Title: **STAGE 1&2 ROAD SAFETY AUDIT**

Colpe Road, Drogheda, Co. Meath

Client: **DBFL Consulting Engineers.**

Report reference: **0583R02**

Drawing 170092 – 2054, Colpe Road, Chainage 1510.

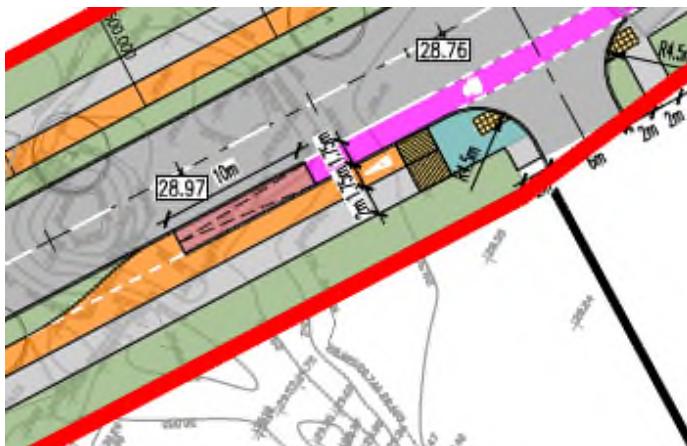
It is unclear if the cycle track on the southern side of Colpe Road is to be a two-way cycle track. The detail at the junction may be confusing for some cyclists. The cycle track does not appear to be wide enough to cater for two-way cycling and could lead to collisions between cyclists and pedestrians.

RECOMMENDATION

It is recommended that the cycle track be one-way only. Similar details have been provided at junctions on the link road.

Drawing 170092-2054.

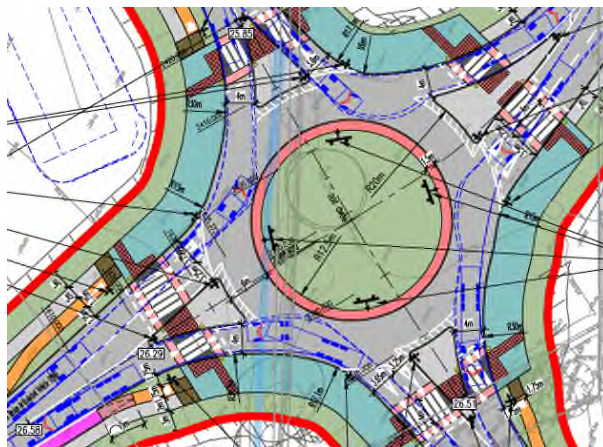
No directional signage has been proposed on approach to, and at the roundabout. This could lead to sudden braking on the circulating carriageway and rear-end shunts. This may particularly be the case as the existing through route is to Donacarne/Bettystown and the straight through at the roundabout now leads to Mill Road and Marsh Road.

It is important that signs can be accommodated in the verges and splitter islands of the roundabout such that they have adequate 'x' height text to be clearly legible, have adequate off set clearance to passing vehicles and do not obscure visibility.

Sign poles in footways and cycle tracks can be hazards to pedestrians and cyclists.

RECOMMENDATION

It is recommended that directional signs are designed and their locations agreed and assessed in advance of construction. Where required the splitter island layouts should be revised or localised verge widening should be undertaken.

Drawing 170092-2057

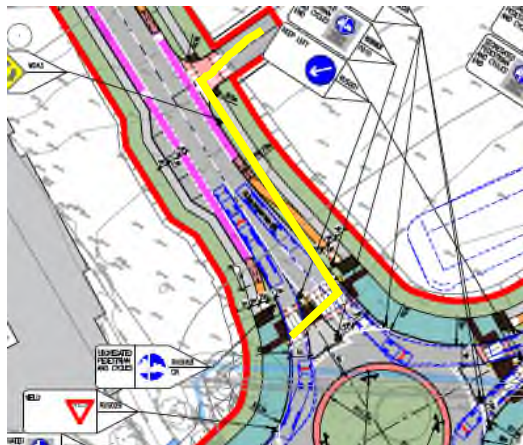
Cyclists travelling northbound wishing to access the proposed school site will have to cross at the toucan crossing and travel contra flow along the southbound cycle lane. This could lead to collisions with southbound cyclists as the facility is only wide enough to cater for one-way cycling.

RECOMMENDATION

It is recommended that the cycle track be made two-way between the toucan crossing and the entrance to the school site.

Drawing 170092-2057

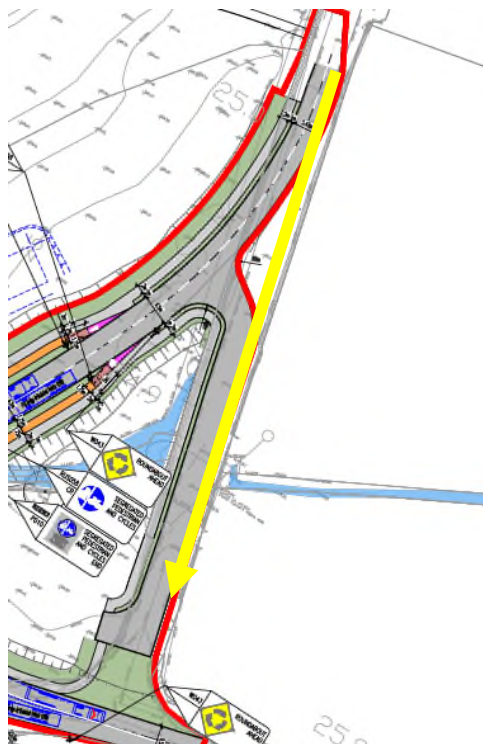
There may be a potential sight-through for southbound drivers on Mill road onto the dead-leg cul-de sac depending on the landscaping and warning provided. This could lead to sudden braking and rear-end shunts.

RECOMMENDATION

It is recommended that suitable landscaping and chevron signage be provided at the new horizontal bend on Mill Road.

Drawing 170092-2057

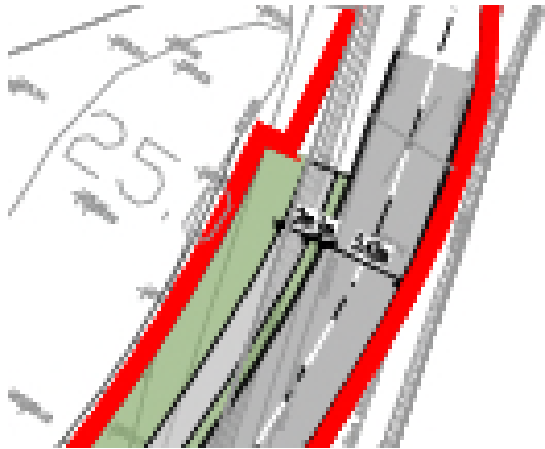
The existing Mill Road has no pedestrian facilities. The proposed realigned section has a footpath behind a narrow grassed verge. Without a suitable transition from off-road to on-road there may be cases where pedestrians step onto the carriageway and cannot be seen by approaching drivers. There could also be slips and falls where pedestrians have to dismount high kerbs.

RECOMMENDATION

It is recommended that suitable visibility is provided to the crossing point/termination of the footpath and that a dropped kerb is provided.

Drawing 170092-2051

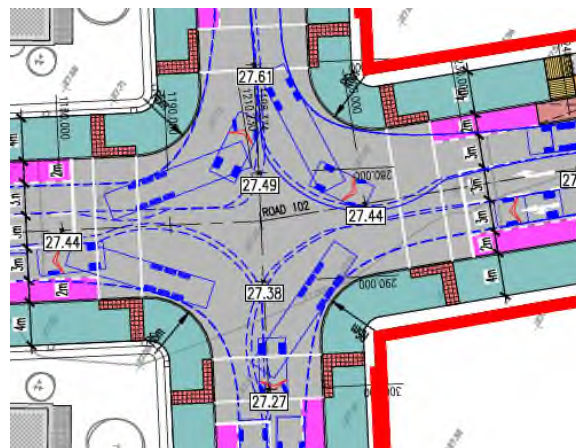
Cyclists wishing to turn right at the signalised junction will not get a chance to start their manoeuvre in advance of vehicular traffic. This could lead to cyclists being squeezed by turning vehicles and possibly being knocked from their bicycles.

RECOMMENDATION

It is recommended that advance stop lines be provided for cyclists.

Drawing 170092-2051, chainage 220, East -West Side road to link Road

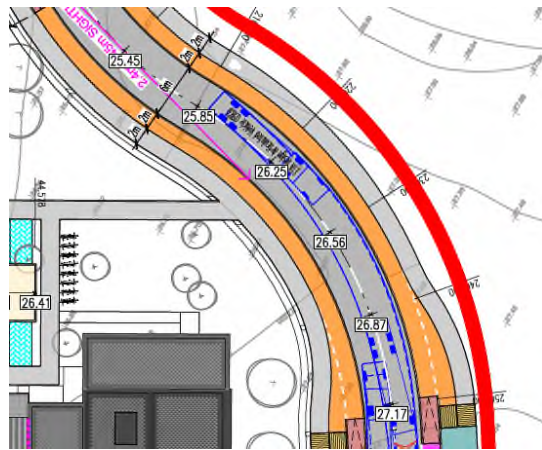
The swept path analysis for a HGV travelling West towards the link road signalised junction shows that it crosses the centerline of the carriageway for a substantial distance. It appears that a car could not pass a HGV at this location. This could lead to side-swipe collisions. It is assumed that when the link road is complete there may be a substantial number of HGVs including this route. This is also an area where queuing would occur on approach to the junction and this may lead to a road block leading to drivers having to reverse which could lead to collisions with other vehicles.

RECOMMENDATION

It is recommended that the horizontal alignment be modified at this location and possibly East where a swept path analysis has not been shown.

Drawing 170092-2051, chainage 120.

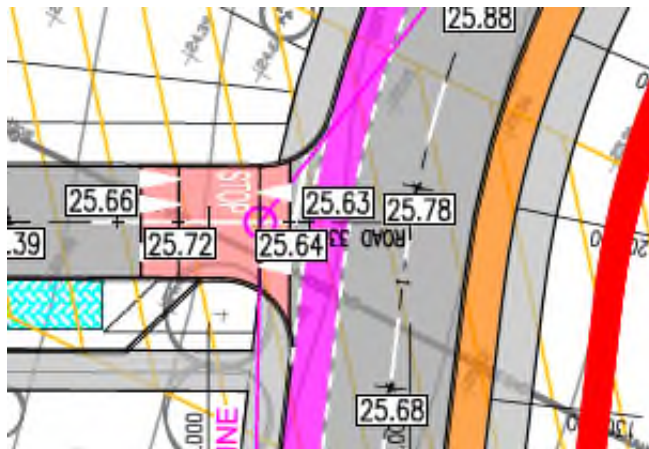
There is no pedestrian crossing provided across the priority junction at Chainage 120 on the Link Road. This could lead to pedestrians crossing on the ramp of the raised table and losing balance as they cross or having to mount high kerbs and not being able to do so if they are mobility impaired.

RECOMMENDATION

It is recommended that the layout is changed so that the mobility impaired can cross easily.
